**UNITED STATES OF AMERICA  
NUCLEAR REGULATORY COMMISSION  
BEFORE THE COMMISSION**

In the matter of  
Pacific Gas and Electric Company  
Diablo Canyon Nuclear Power Plant  
Units 1 and 2

**PETITION BY SAN LUIS OBISPO MOTHERS FOR PEACE, FRIENDS OF THE EARTH  
AND ENVIRONMENTAL WORKING GROUP FOR SHUTDOWN OF  
DIABLO CANYON NUCLEAR POWER PLANT DUE TO UNACCEPTABLE RISK OF  
SEISMIC CORE DAMAGE ACCIDENT**

**DECLARATION OF PETER BIRD, Ph.D**

**Mark-up (in red) by P. Bird, 2023 of  
Figure 13-17 of SSC for DCP  
(PG&E, 2015)**

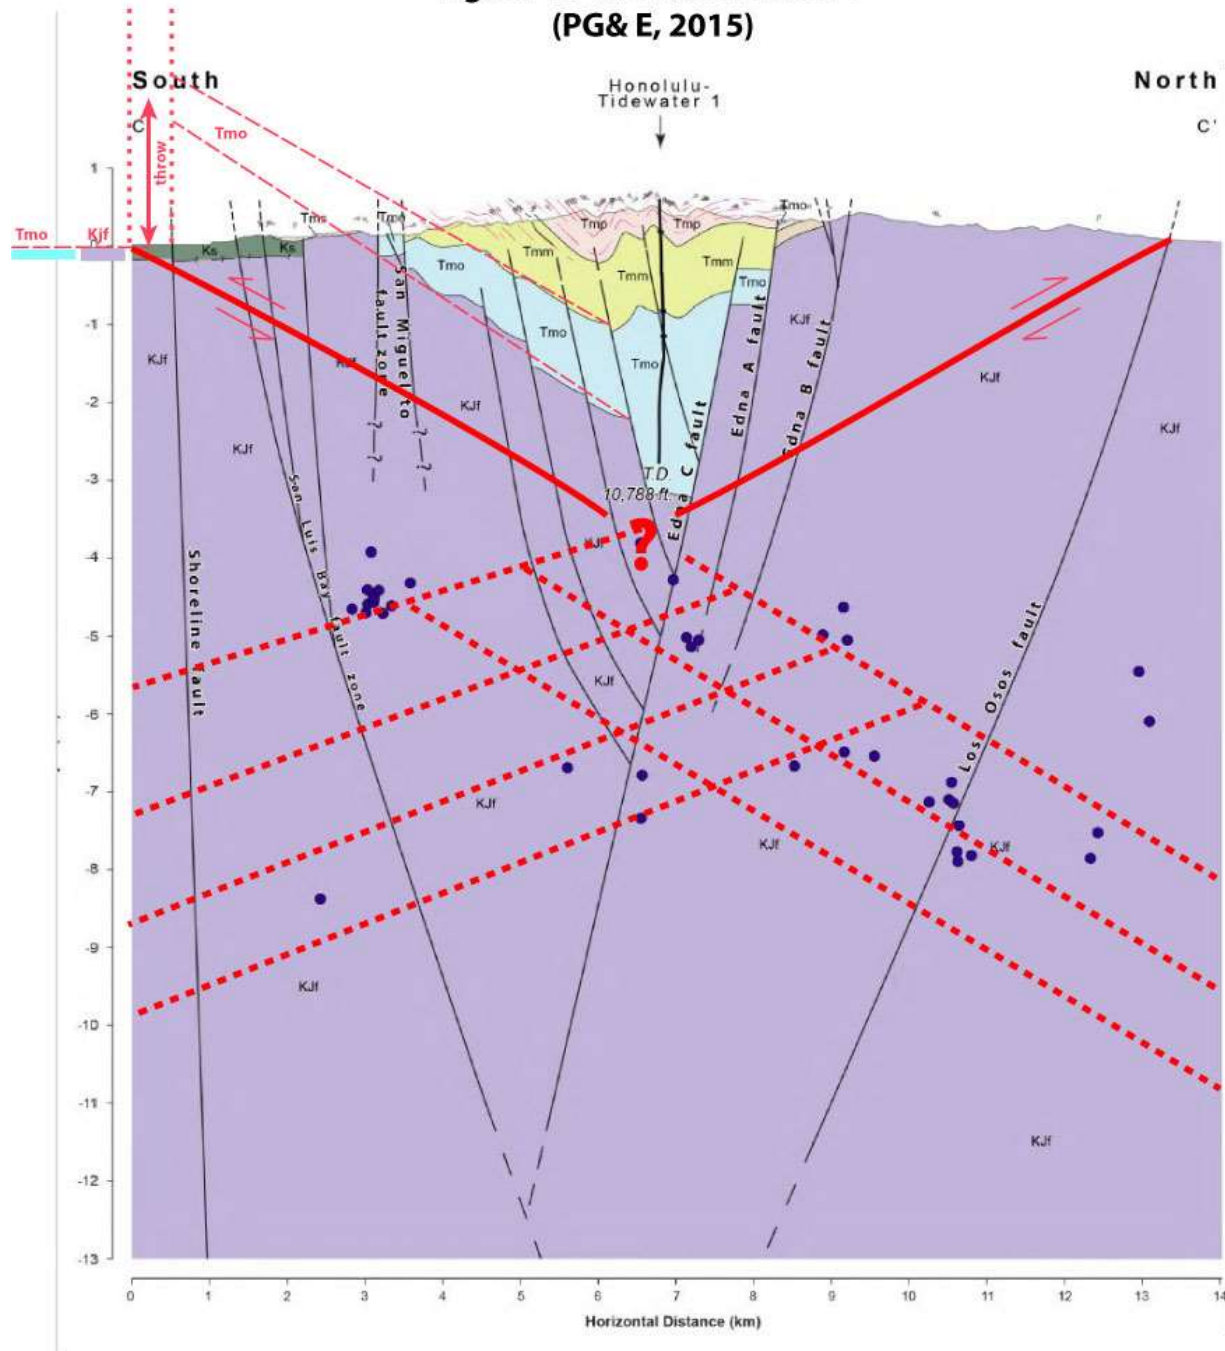
- b. According to the geologic map [PG&E, 2014] and associated cross-section C-C’ in its Fig. 13-17, the apparent throw (vertical offset) of stratigraphic unit Tmo Obispo Formation is 1.6~2.2 km across the Shoreline fault trace. (This measurement is illustrated in my own Figure 1.) None of this can be explained by strike-slip on the Shoreline fault because its slip-rate is very low and because regional strikes of bedding are roughly parallel to it. Instead, the simplest explanation is thrust-faulting on the Inferred Coastline thrust that shares the complex, braided surface trace of the Shoreline fault. Assuming a typical thrust-fault dip of 25°, the amount of slip required to create this throw is  $(1.6\sim 2.2 \text{ km}) / \sin(25^\circ) = 3.8\sim 5.2 \text{ km}$ . Then, assuming this occurred since ~5 Ma, the mean rate of slip on the Inferred Coastline thrust has been 0.76~1.04 mm/a. To the northwest of section C-C’ the throw of unit Tmo becomes much less, but the area of neotectonic uplift of the Irish Hills (Figure 7-4 in PG&E, 2015) continues to the northwest; so there the thrust fault probably does not terminate but merely deforms unit Tmo into a fault-initiation anticline above it. (In this area, complex older deformation associated with intrusions of Tmod diabase obscures the Pliocene-Quaternary structure, and makes balanced-section methods inapplicable.) In my professional judgment, this Inferred Coastline thrust fault continues, with the same rake and offset, northwest to the Hosgri fault.

Figure 1. Revised geologic section through the Irish Hills near DCP. The base for this figure is Figure 13-17 of the Seismic Source Characterization for DCP (PG&E, 2015). Note that the fault dips suggested by black lines in their figure were not based on data, but were constrained by PG&E's (2015) *a priori* assumption that only strike-slip tectonics is active in the area. In red, I have suggested more plausible 25° dips for the Los Osos thrust (at right/North) and the Inferred Coastline thrust (at left/South). The upper-left portion of this figure is also edited to show the throw (vertical offset) of map unit Tmo across the Inferred Coastline thrust, discussed in my text paragraph IV.B.25(b).
